**Re: *Addendum No. 2***  
***Southland Road Drainage System Improvements***  
***City of Mentor-on-the-Lake***

Date: November 11, 2024

**CONNECTION TO EXISTING DRAINAGE STRUCTURE DETAIL**

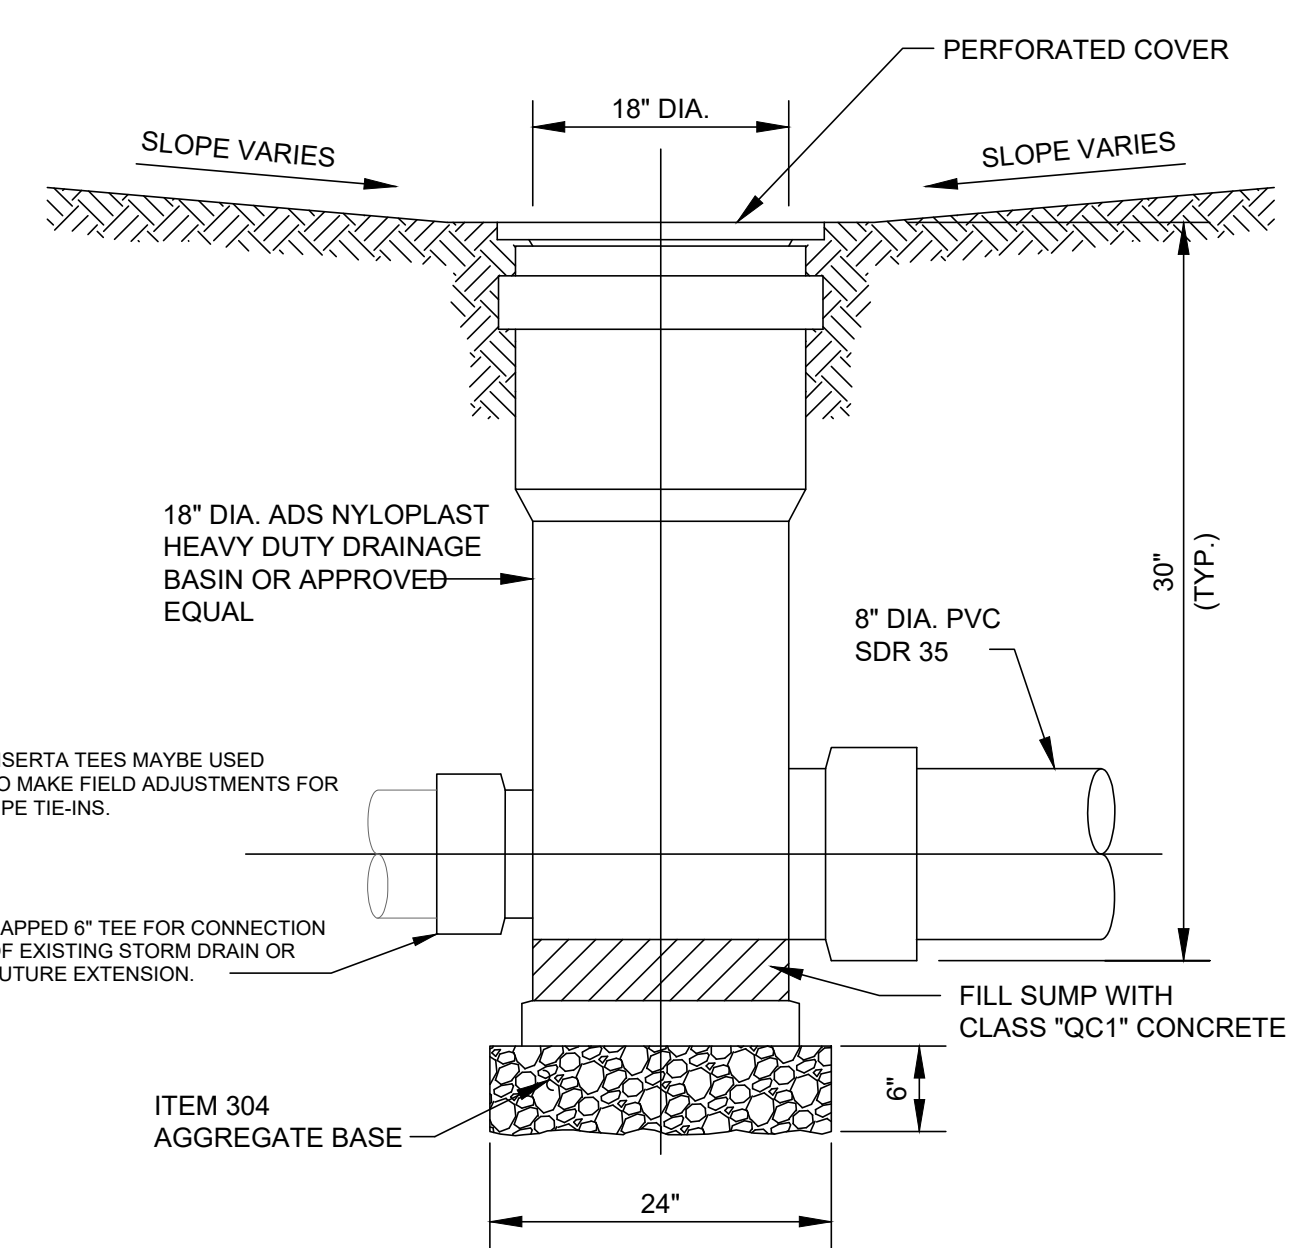
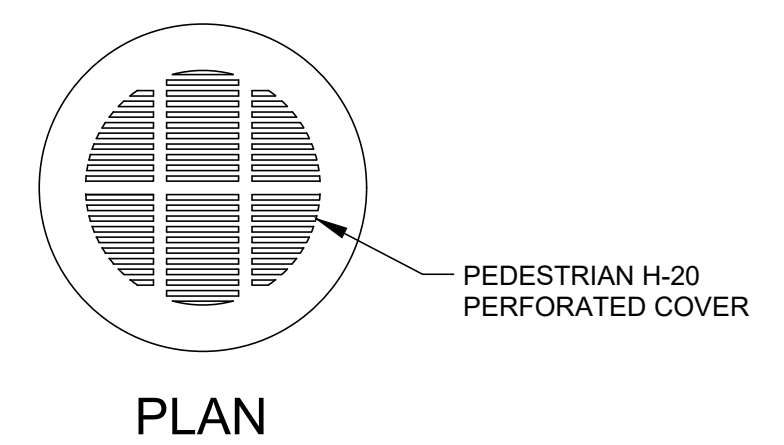
DETAIL WAS REMOVED.

NO	REVISION	DATE
1	REVISED FOR ADDENDUM #2	11/11/24

PROJECT NO.	
<b>210645</b>	
DISCIPLINE	
<b>CIVIL</b>	
SHEET NAME	
<b>MOT-1</b>	
SHEET	OF
<b>06</b>	<b>14</b>

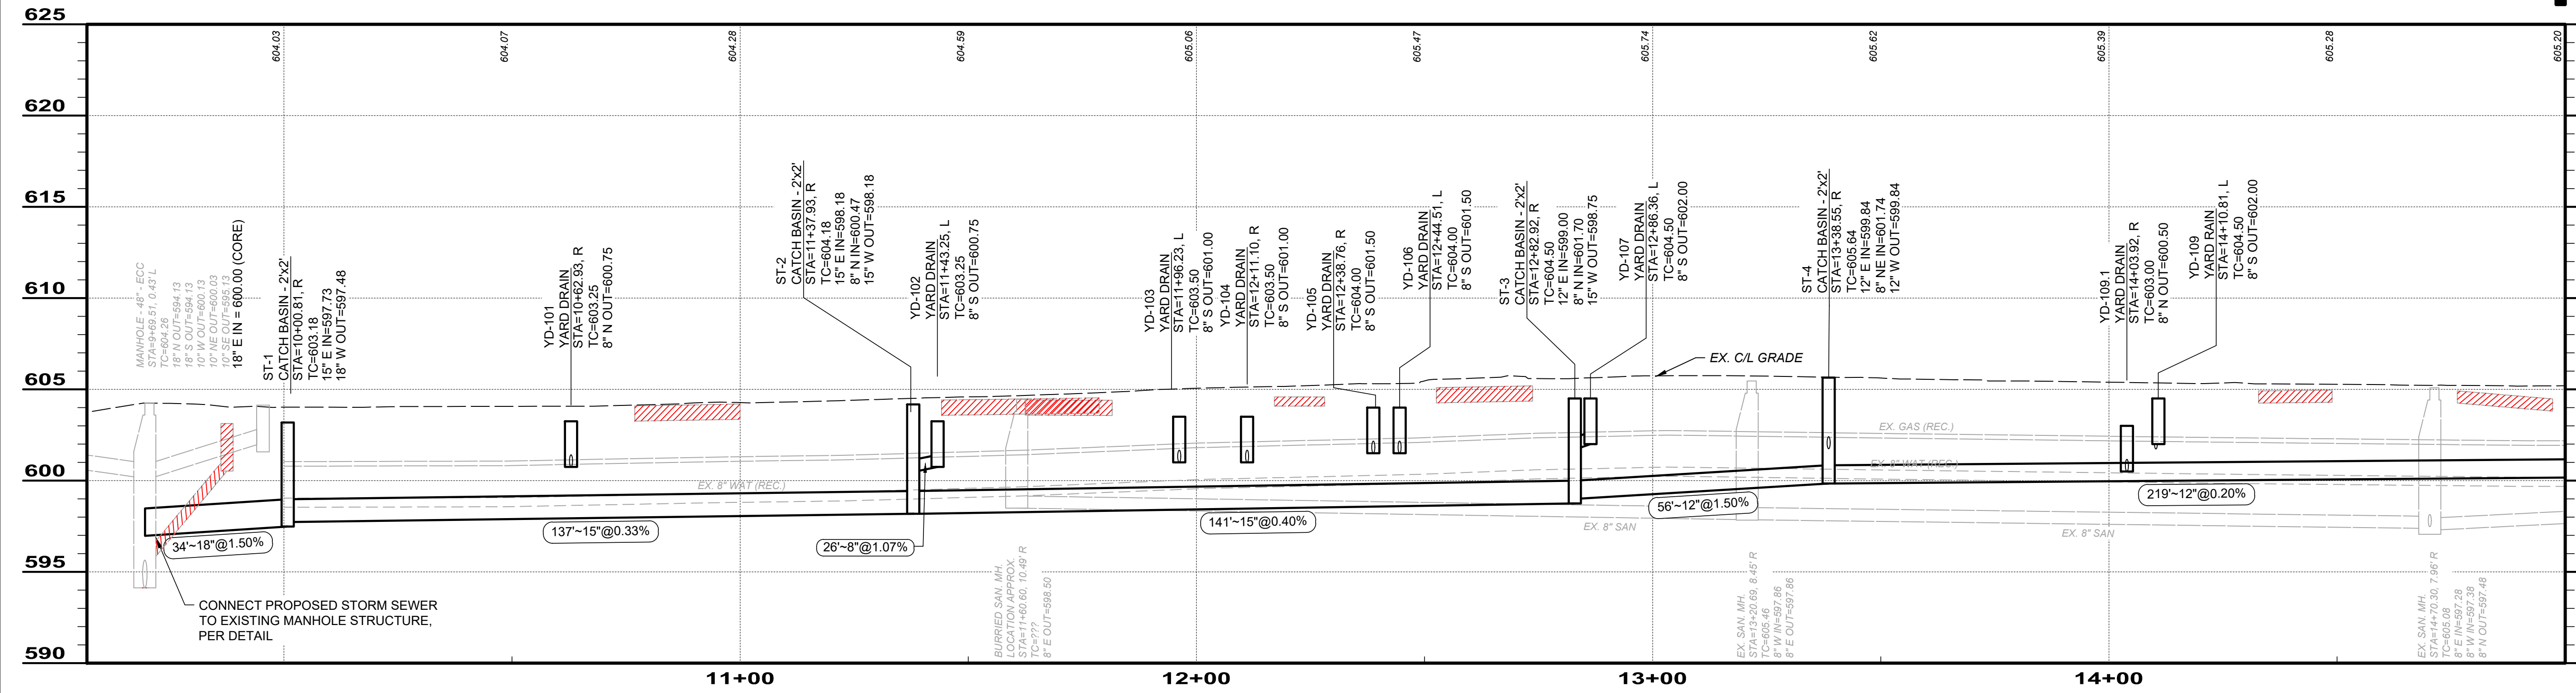
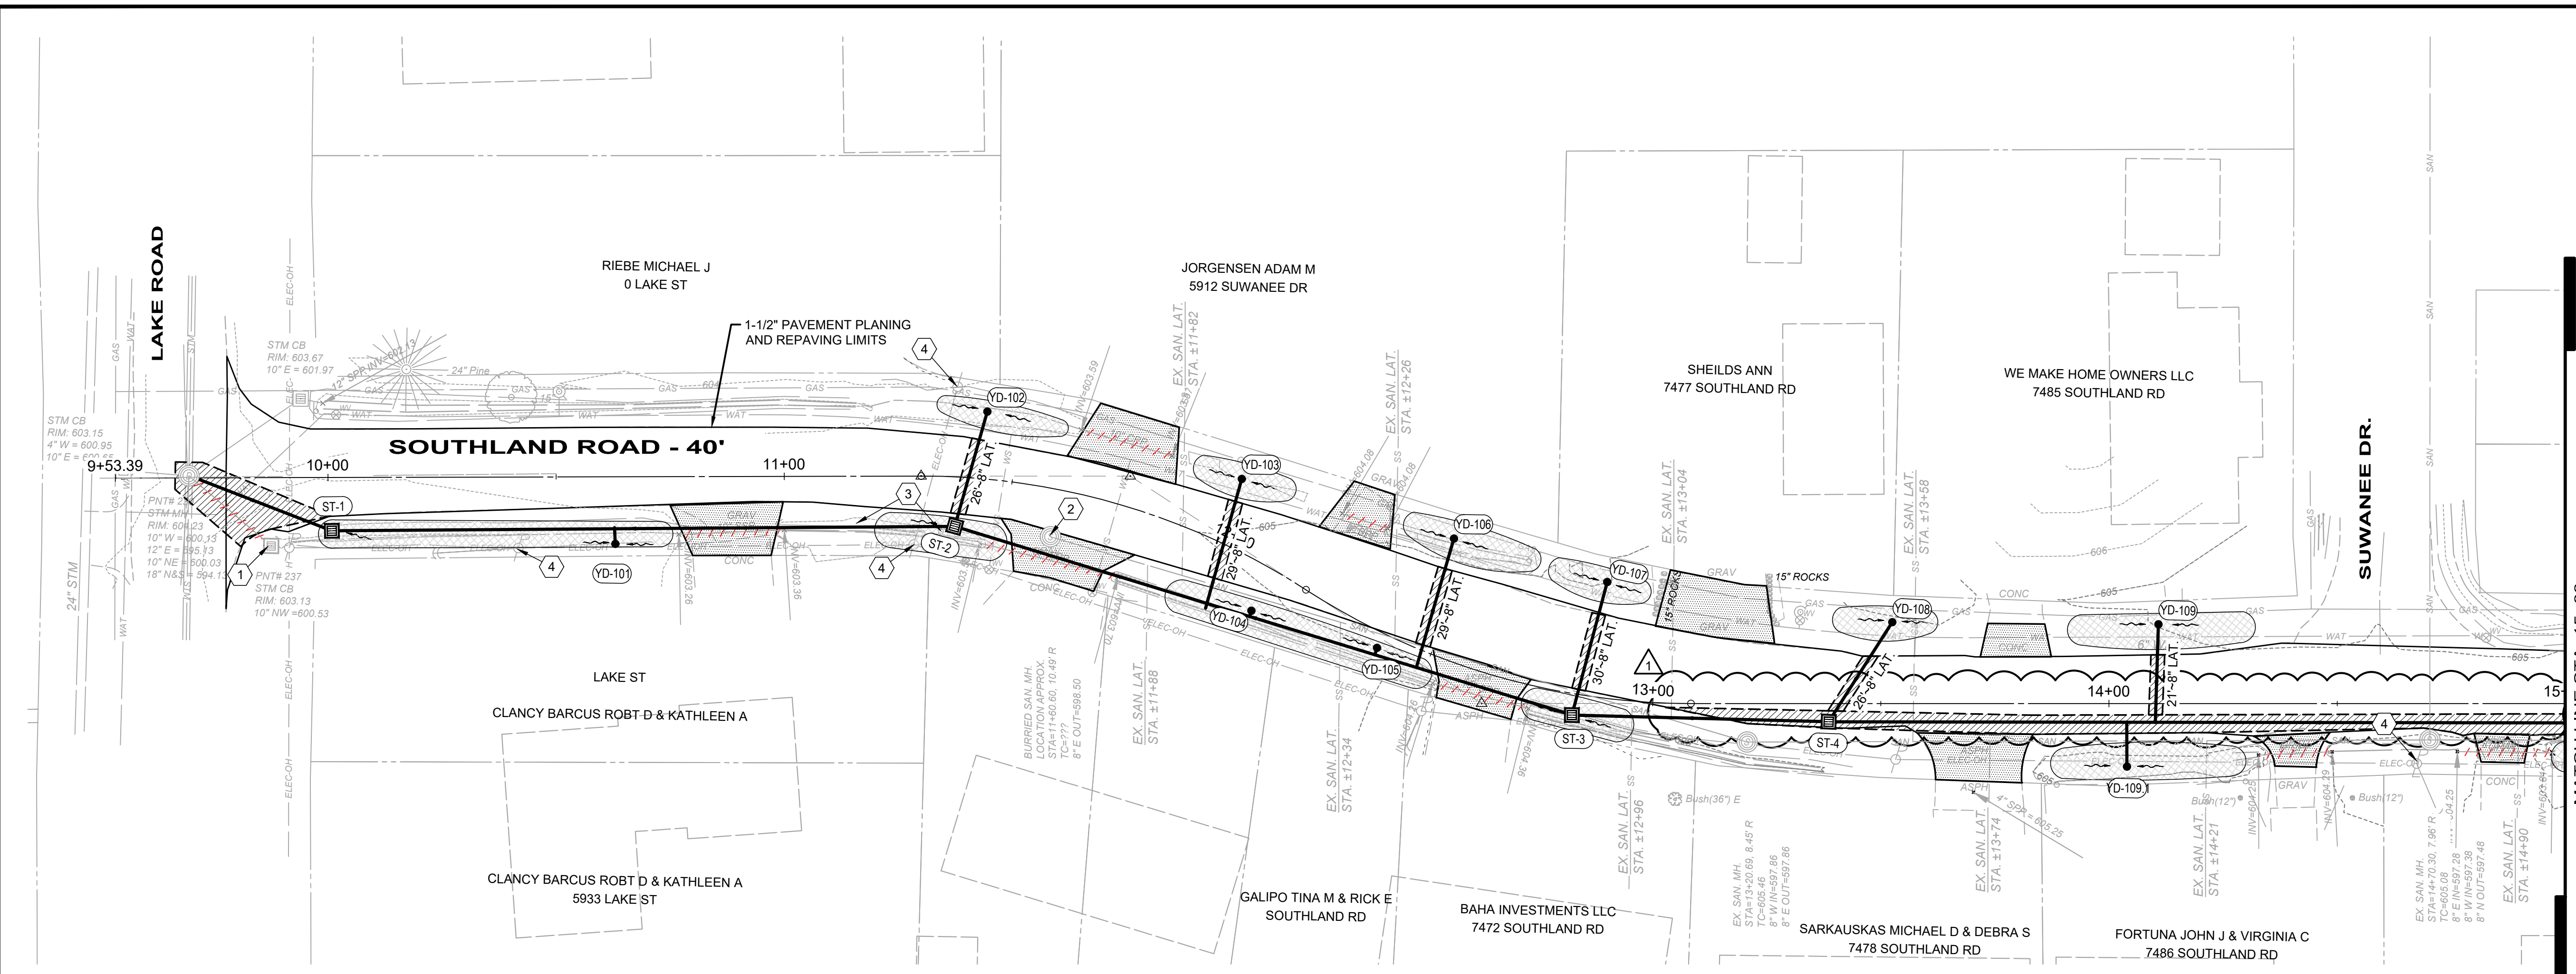
- ① REMOVE EXISTING STORM CATCH BASIN STRUCTURE.
- ② ADJUST CASTING TO MEET PAVEMENT GRADE.
- ③ CONTRACTOR SHALL REMOVE, STORE AND RESET EXISTING ROADWAY SIGN AND POST TO FACILITATE CONSTRUCTION.
- ④ CONTRACTOR SHALL COORDINATE WITH FIRST ENERGY TO SCHEDULE UTILITY POLE SUPPORT DURING CONSTRUCTION. (800-589-3101)
- ⑤ NOT USED
- ⑥ NOT USED
- ⑦ NOT USED
- ⑧ NOT USED
- ⑨ NOT USED
- ⑩ NOT USED

NO	REVISION	DATE
1	REVISED FOR ADDENDUM #2	11/11/24
